City of El Paso – City Plan Commission Staff Report

Case No: PZDS16-00009
Application Type: Detailed Site Development Plan Review
CPC Hearing Date: May 5, 2016
Staff Planner: Jeff Howell, 915-212-1607, howelljb@elpasotexas.gov

1 DETAILED SITE DEVELOPMENT PLAN
SCALE: 1" = 20'-0"

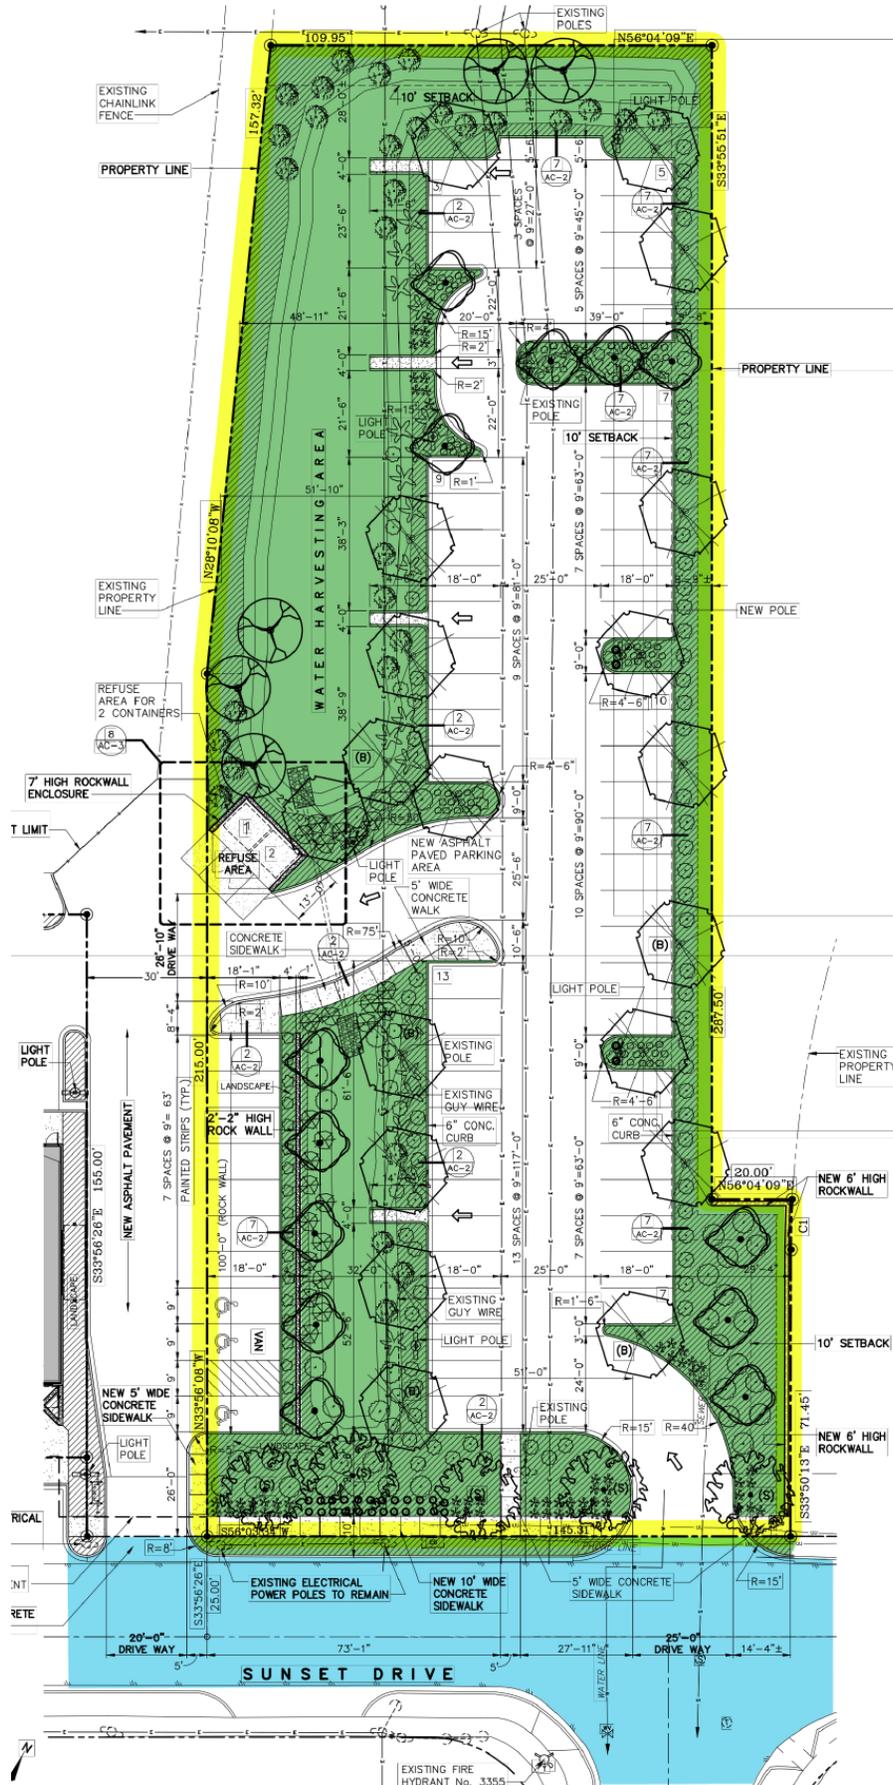
1. Add to general notes: On site ponding is required in compliance with sections (DSC, 19.19.010A and DDM, 11.1).
2. Show proposed drainage flow patterns and label the proposed private ponding locations.
3. Approval of the site plans by CPC constitutes a determination that the applicant is in compliance with the minimum provisions. Applicant is responsible for the adequacy of such plans, insuring that stormwater is in compliance with ordinances, codes, DSC, and DDM. Failure to comply may require

the applicant to seek re-approval of the site plans from CPC.
